## ADDENDUM NO. 04

Project Name: Aston Township Municipal Complex

Project No.: 2301.00-22

Date of Issue: April 23, 2024

**SD-A07**

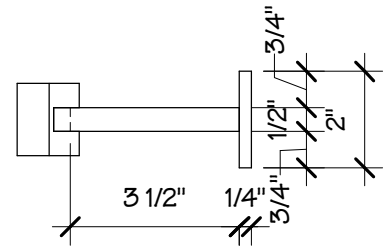
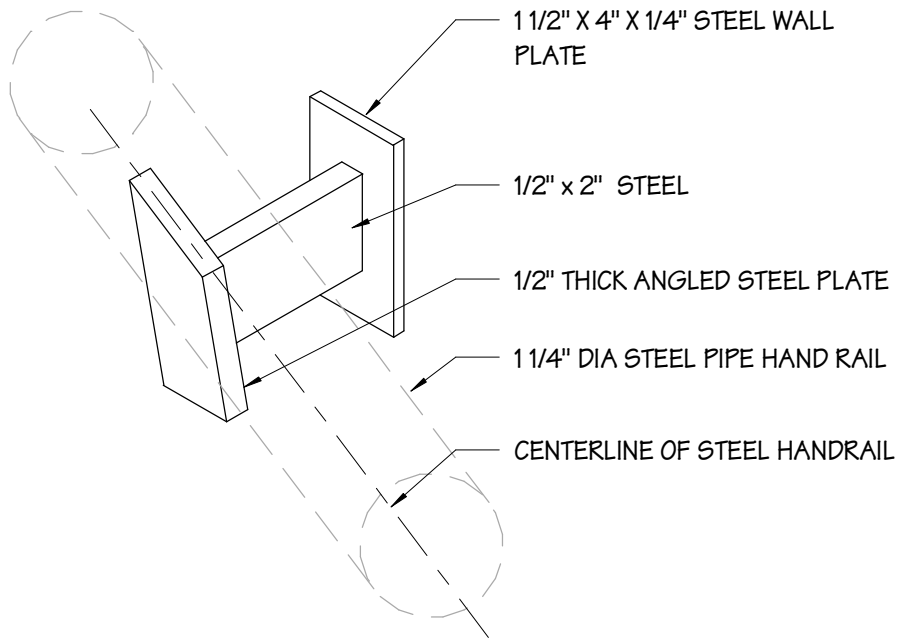
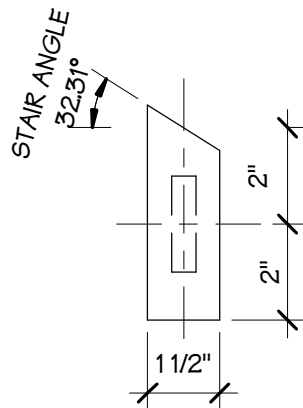
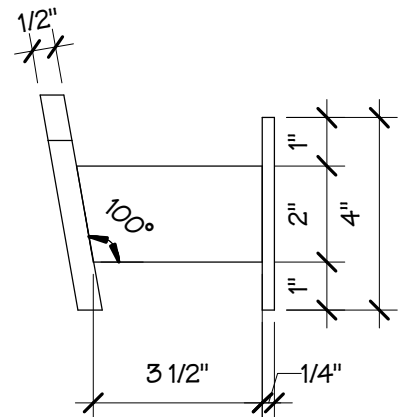
- 14. Reference to Sheet A-102 – Second Floor Plan; Drawing 1/A-102 - Second Floor Plan: Refer to supplemental drawing SD-A07 – Meeting Room 201 – East Elevation that is attached to this addendum for an elevation and section references of the casework that shall be provided in this room.

**Sheet Number:**  
**SD-A08**

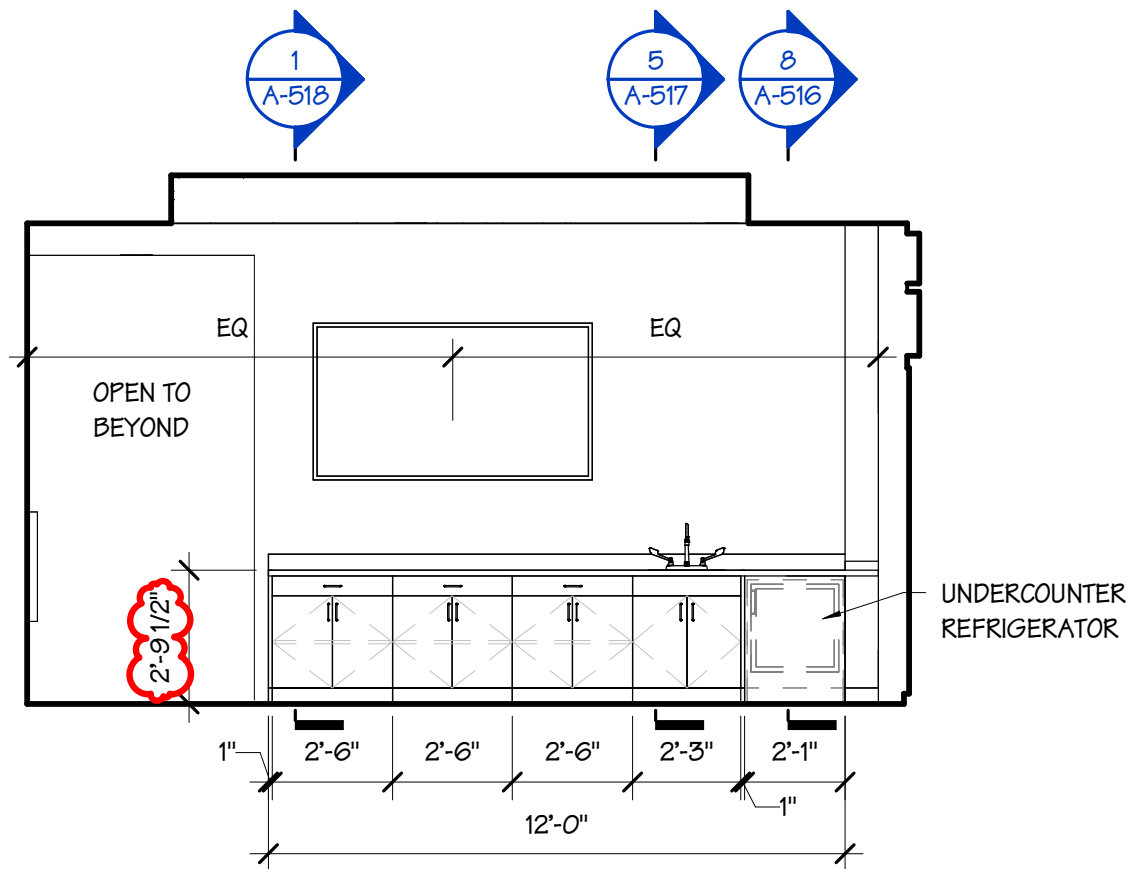
- 16. Reference to Sheet A-413 – Police Department Stairs; Drawing 8/A-413 - Section at Railing (typ): Refer to supplemental drawing SD-A08 – Handrail Wall Bracket that is attached to this addendum for additional details and profile of the handrail wall bracket.

Sheet Number:  
**SD-A10**

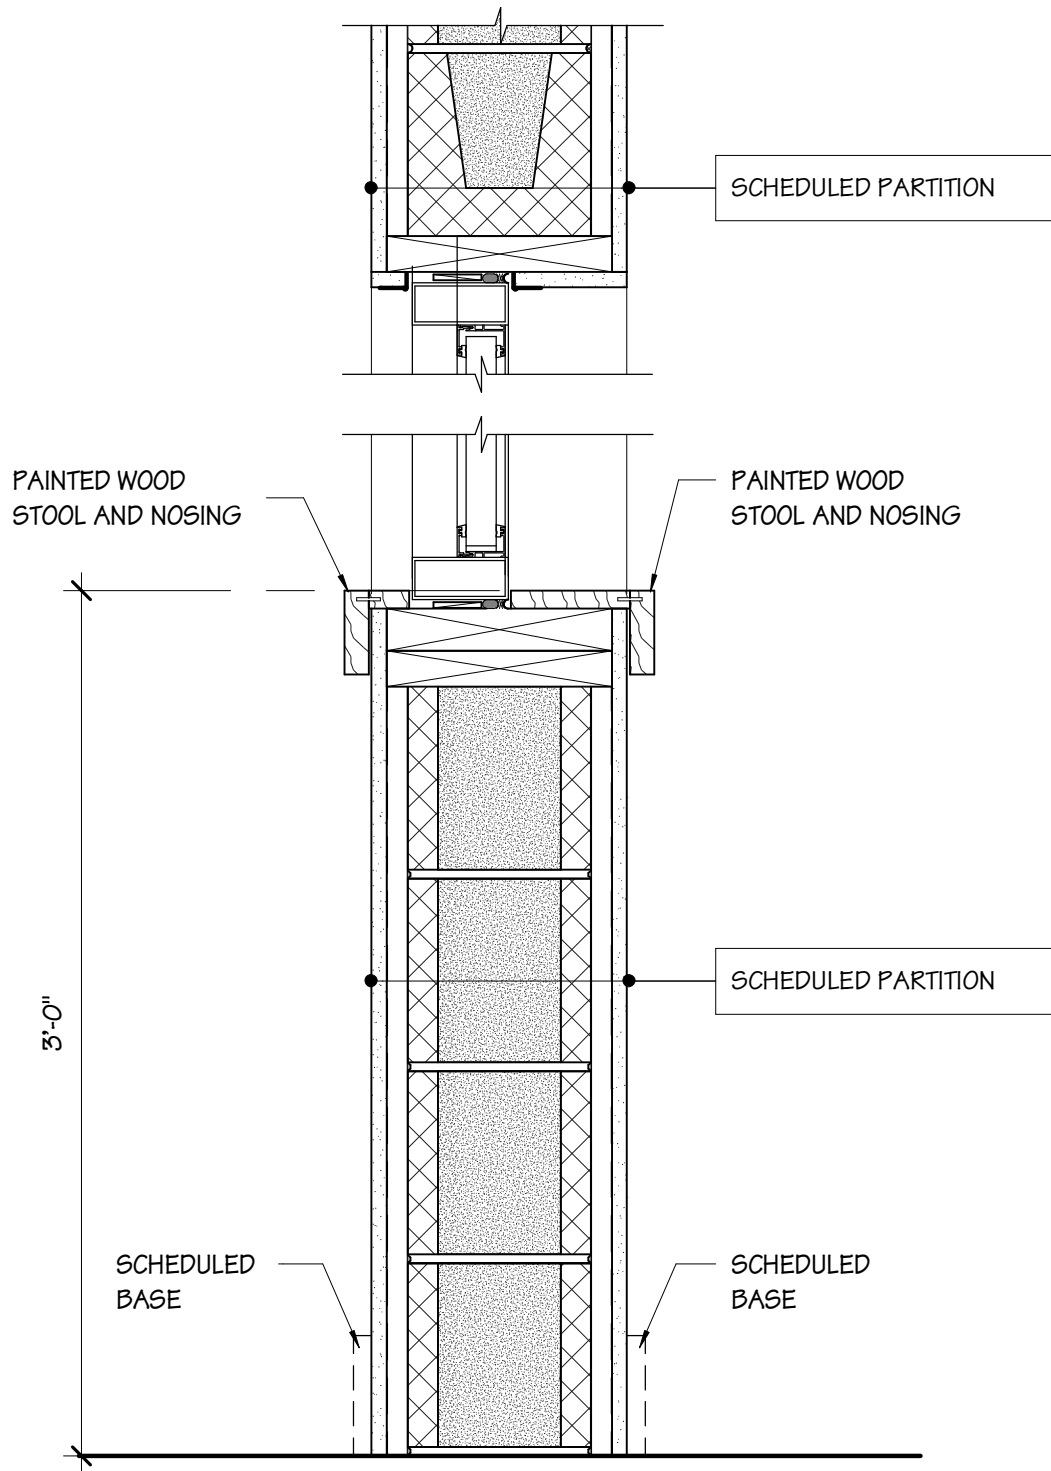
20. Reference to Sheet A-519 – Casework Details; Drawing 7/A-519 - Transaction Counter Section: Refer to supplemental drawing SD-A10 – Police Transaction Counter Section that is attached to this addendum for partial revisions to drawing 7/A519. SD-A10 includes revisions to the countertop and sill of the transaction window. Jamb detail of this window is similar to the head condition shown.

Sheet 4 of 9  
PROJECT  
Aston Municipal Bldg  
DRAWN  
39561  
FILE  
3864

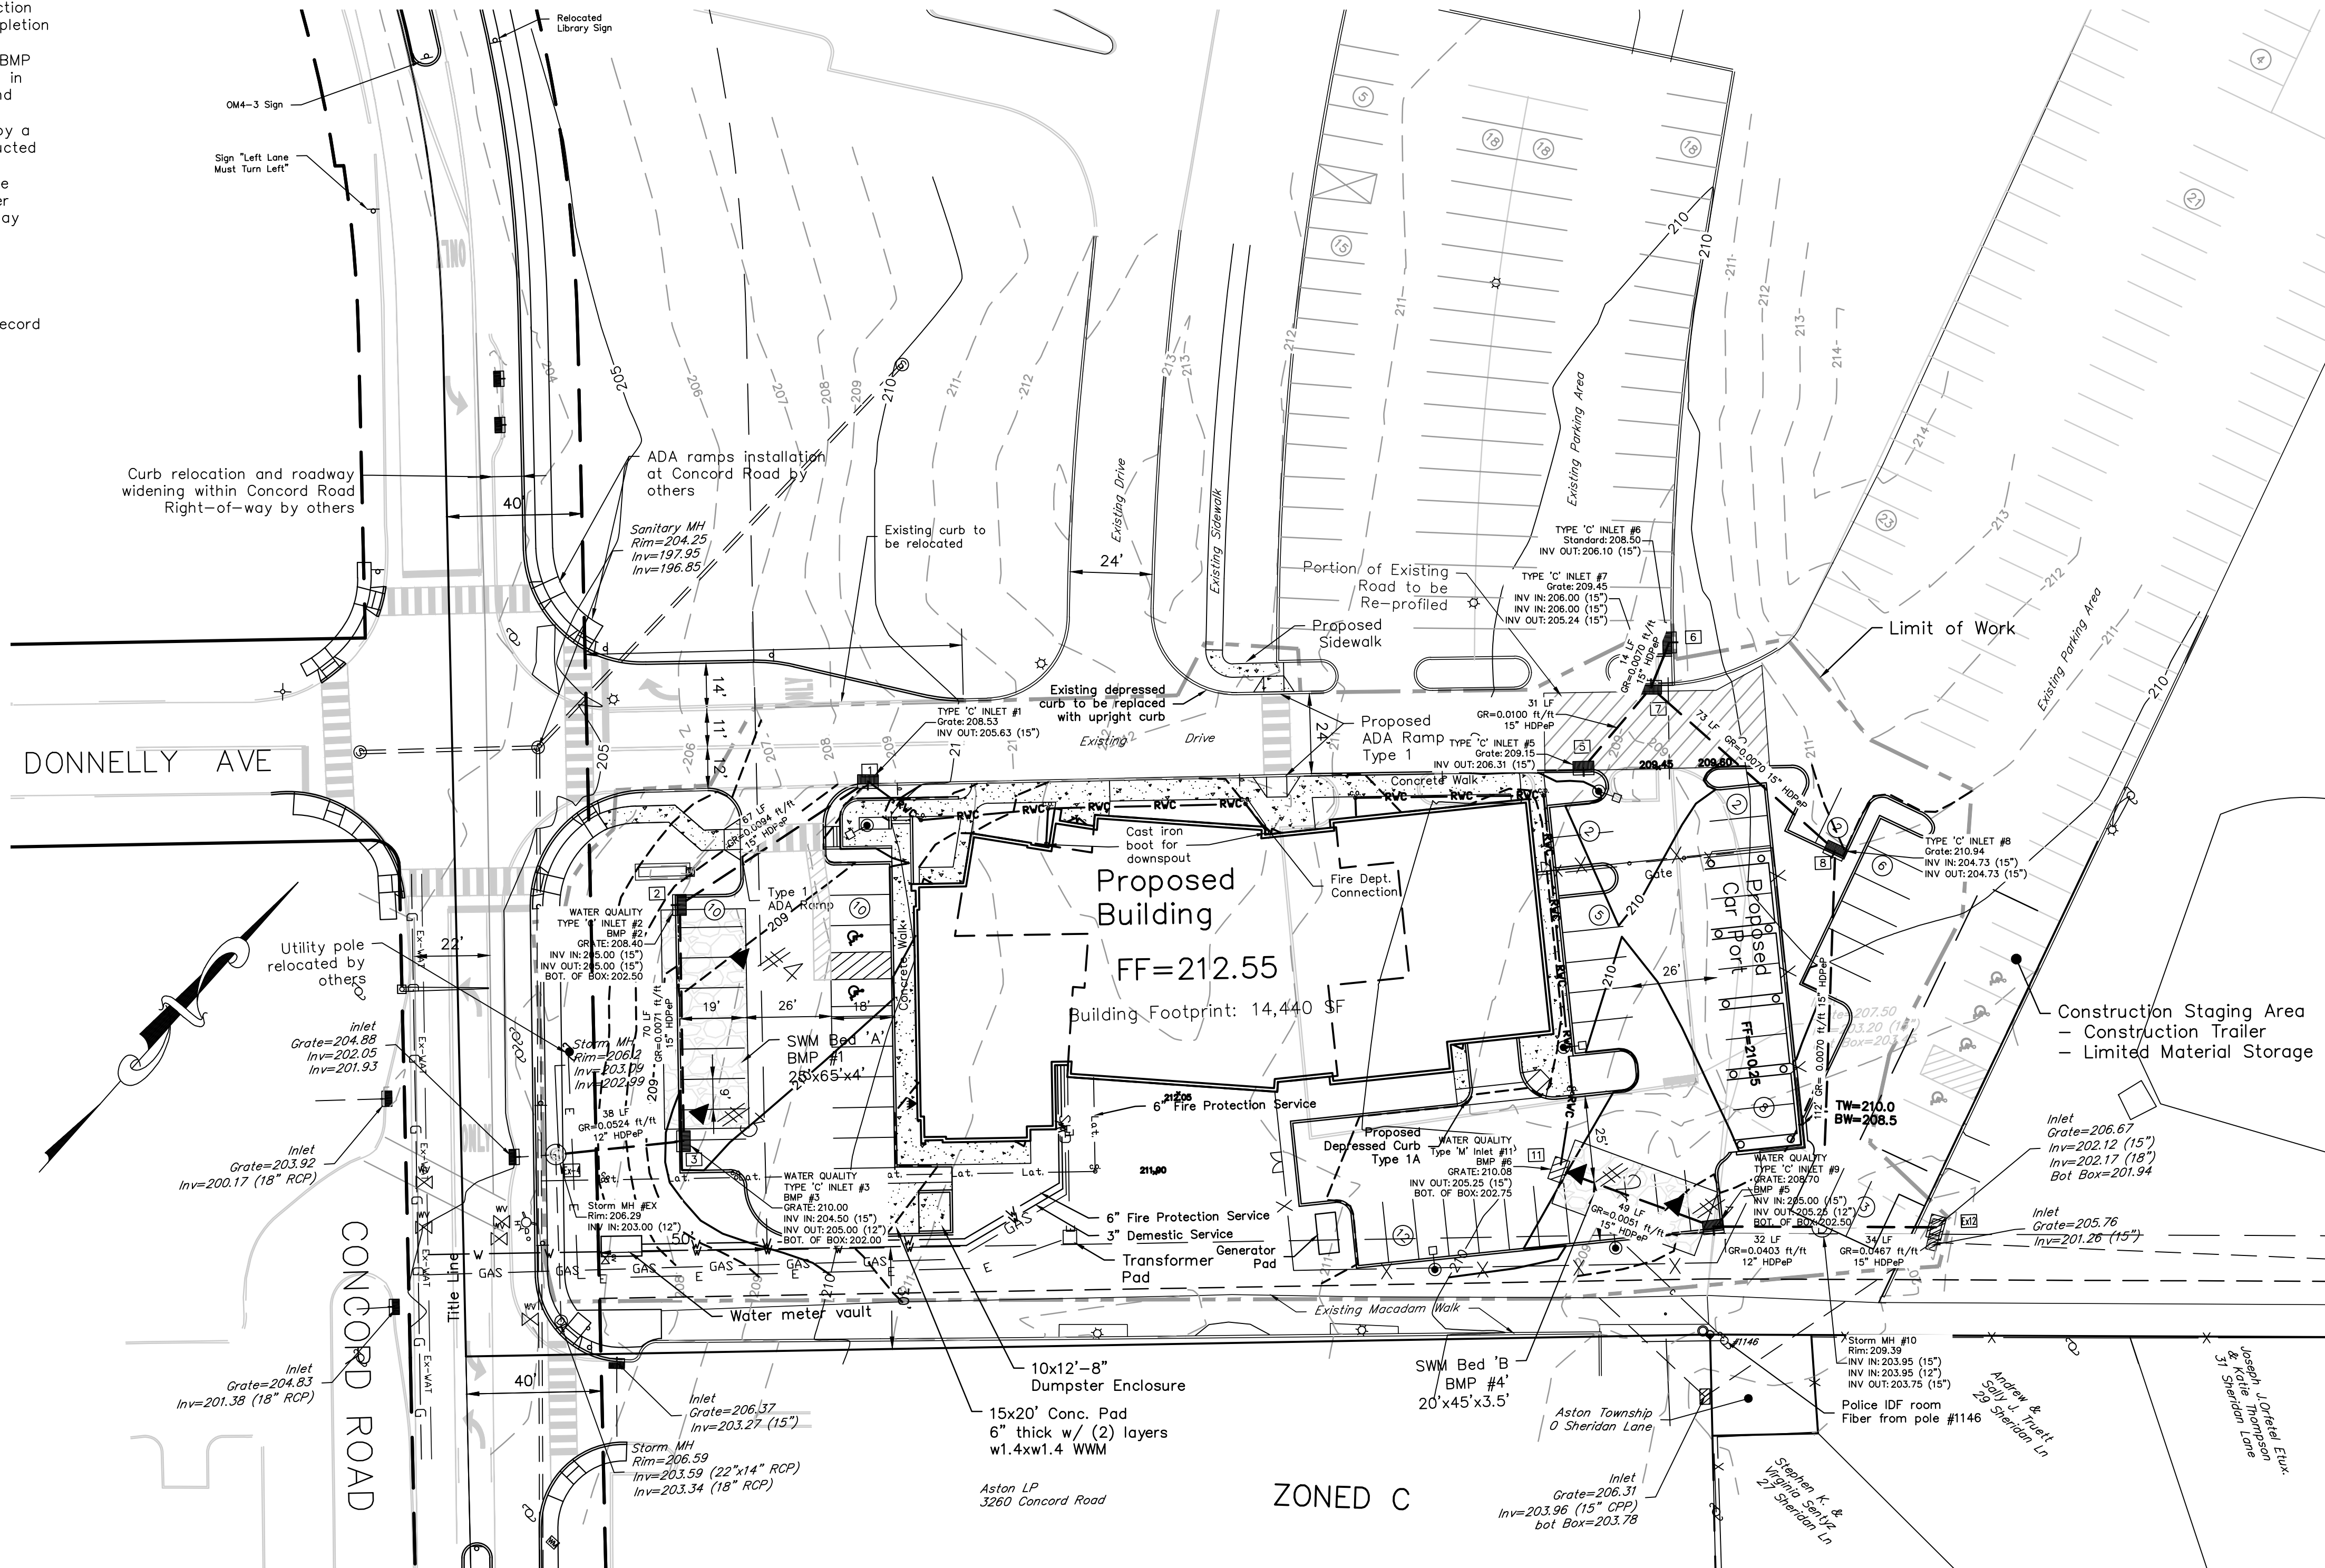
2. Reference to Civil Sheet 4 of 9 – Grading Plan: Civil Sheet 4 of 9 – Grading Plan is being reissued as part of this addendum. A Construction Staging Area (Construction trailers and limited material storage) has been designated at the existing paved parking area northeast of the proposed building.

**S-202**

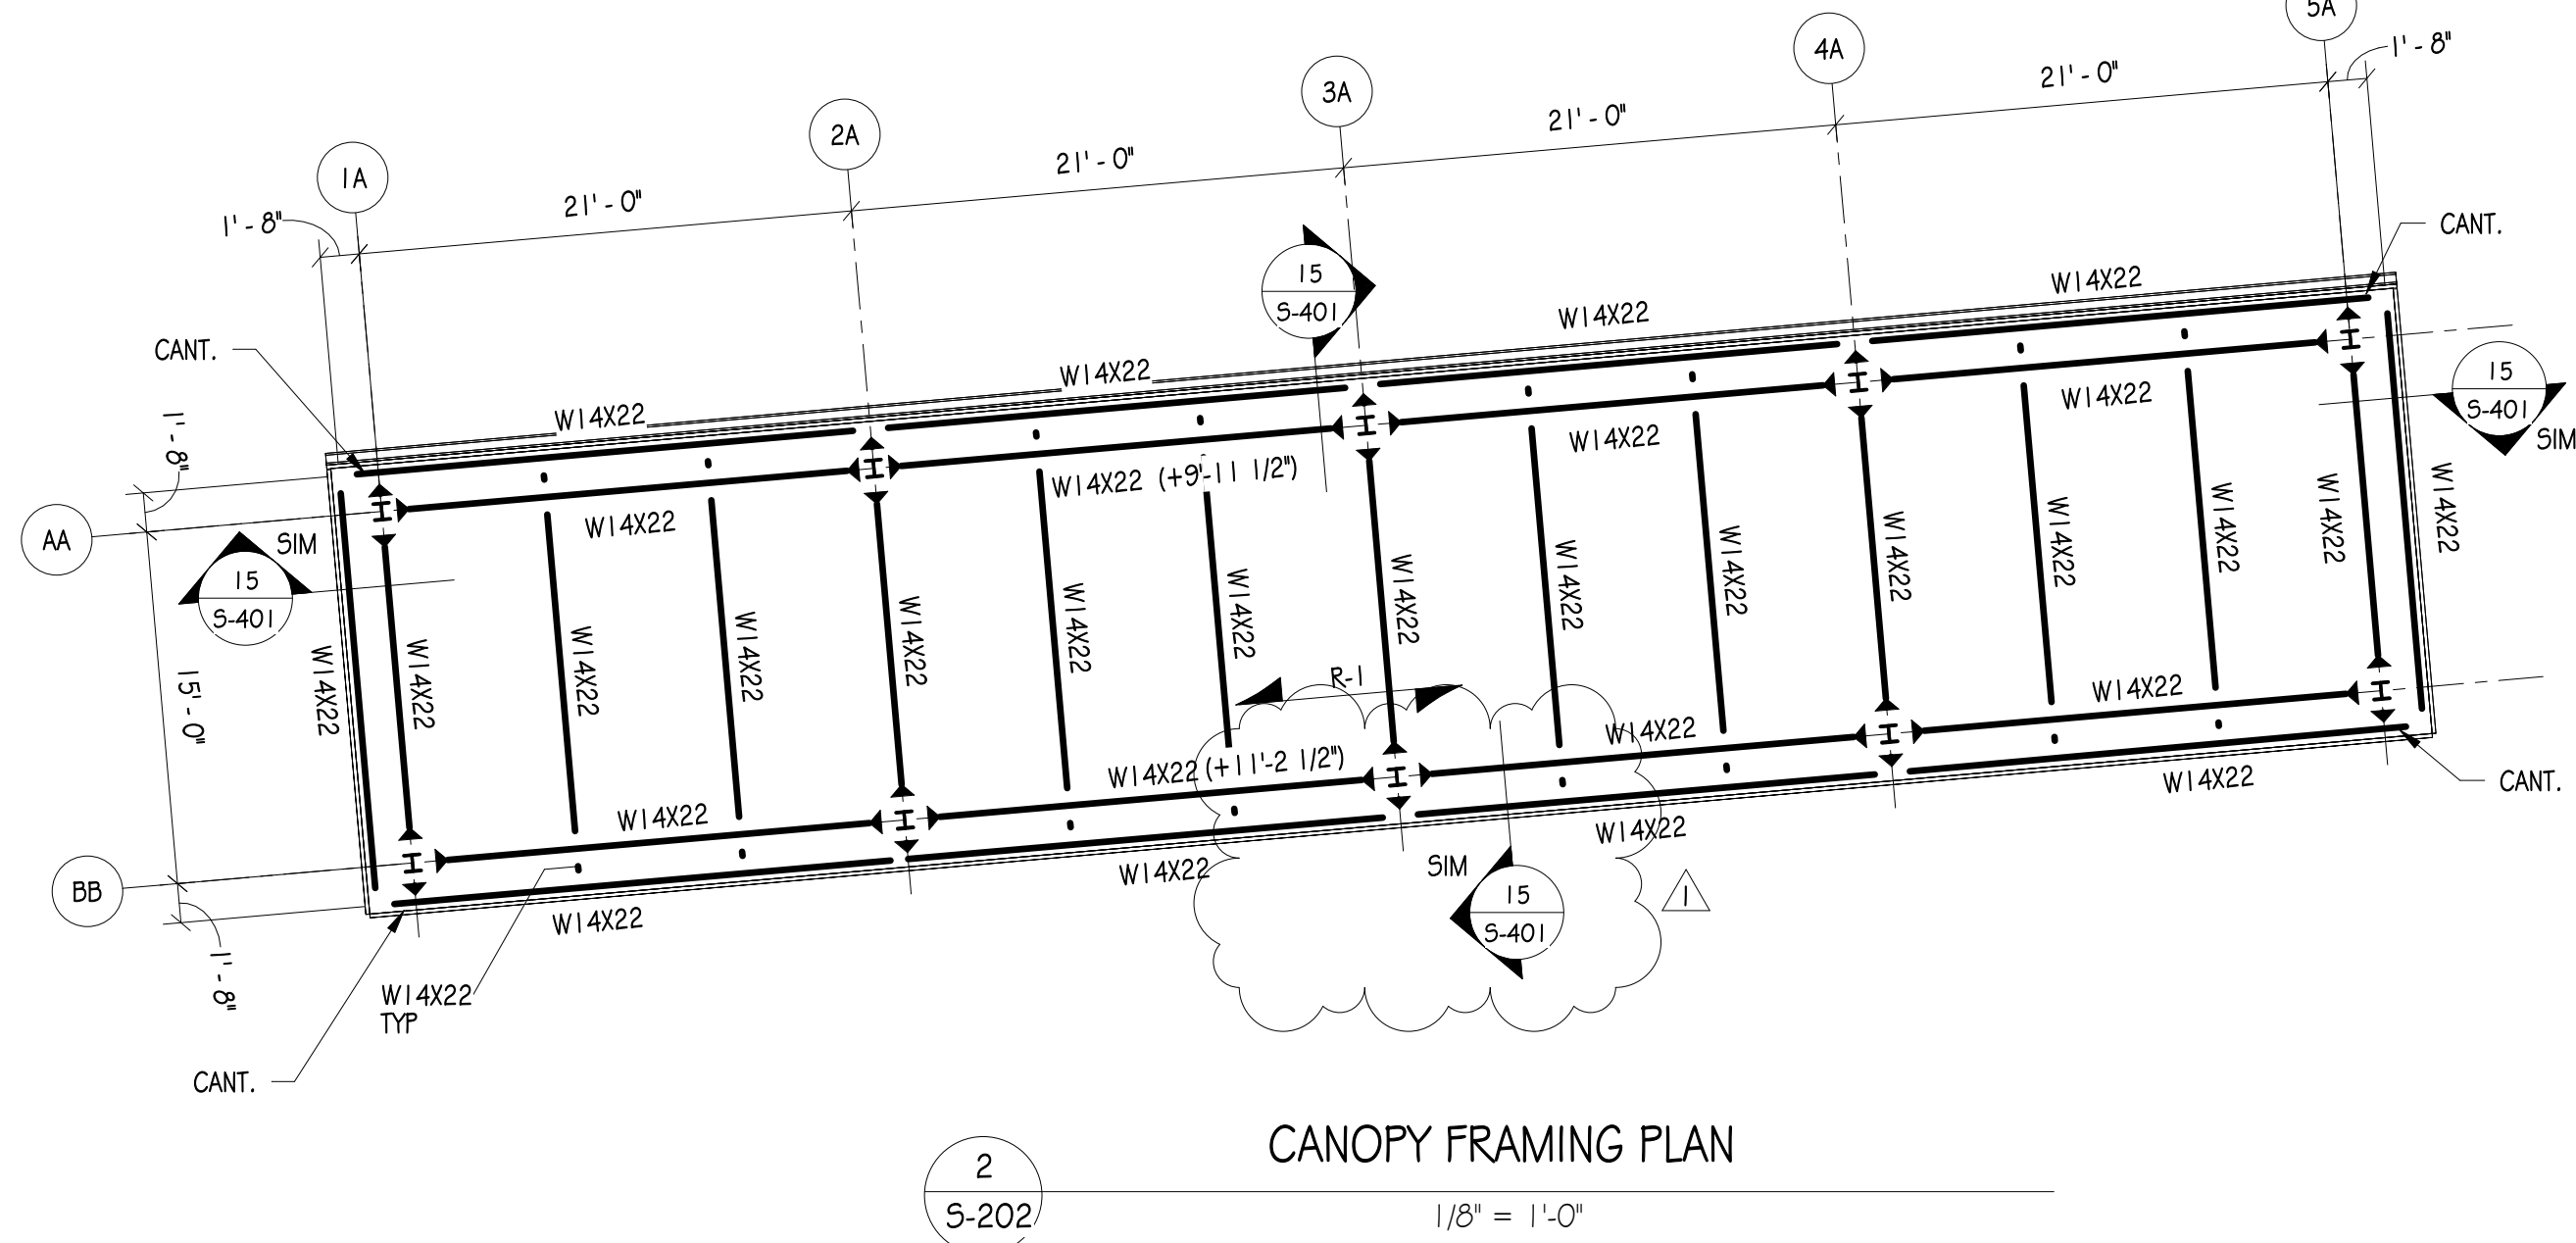
- d. Added foundation under interior masonry wall.
  - e. Extended site wall at canopy foundation plan.
5. Reference to Sheet S-202 – Second Floor Framing/Low Roof Plan: Sheet S-202 – Second Floor Framing/Low Roof Plan is being reissued as part of this addendum. The following clarifications have been made:

- a. Added beam labels at canopy by Stair 2.
  - b. Added section cuts at canopy by Vestibule 100.
  - c. Added floor type at Meeting 201.
  - d. Added roof type above and bottom of deck elevations at low roof levels.

- e. Added lines for RTU support angle frames.
  - f. Added roof section cut above Toilet 158.
  - g. Added “SIM” to section cut 15/S-401 along grid line BB.
